Work Order ID 69254

Item Name: Crosstube Turning Detail

DRAWING NO. D412-664-243	TITLE CROSSTUBE ASSEMBLY (412 HI AFT)	REV. E	DART AEROSPACE LTD ENGINEERING ORDER		D.E.O. NO. D412-664-243-E-1	SHEET NO. SHEET 1 OF 2	SCALE NTS
DRAWN	CHECKED <i>MP</i>	MFG. APPR. <i>E</i>	APPROVED <i>MP</i>	DE APPR. <i>MP</i>			
DATE 11.03.31	DATE 11/03/31	DATE 11.03.31	DATE 11/03/31	DATE 11.03.31

REMOVED ABRASION STRIP IN FAVOR OF A THIN LAYER OF PROSEAL 890.

**D212-664-243
ASSEMBLY DETAIL**

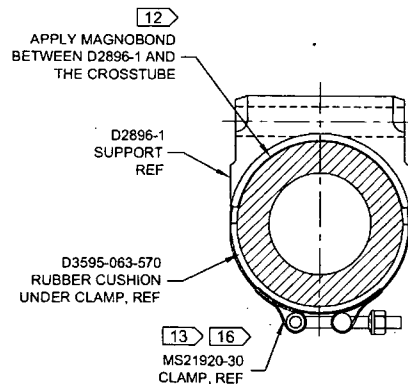
NOTES 2 AND 14, SHEET 1 ARE AMENDED AS FOLLOWS:

- 2) FINISH: CHEMICAL CONVERSION COAT PER DART QSI 005 4.1
PRIME INSIDE AND OUTSIDE PER DART QSI 005 4.2
MASK UNDERSIDE OF CROSSTUBE AS SHOWN (HATCHED AREA)
PAINT OUTSIDE PER DART QSI 005 4.2
AFTER PAINTING, APPLY CLEAR COAT ON HATCHED AREA
- 14) APPLY A THIN COAT OF PROSEAL 890 ON INSIDE CONCAVE SURFACE OF D3189-1
CHAFING SHIELD AND LET CURE PER MANUFACTURER'S INSTRUCTIONS. INSTALL
PROSEAL D3189-1 CHAFING SHIELD ONTO CROSSTUBE BY APPLYING A THIN COAT OF
PROSEAL 890 ONTO CROSSTUBE. BE SURE TO ELIMINATE ANY AIR GAPS.
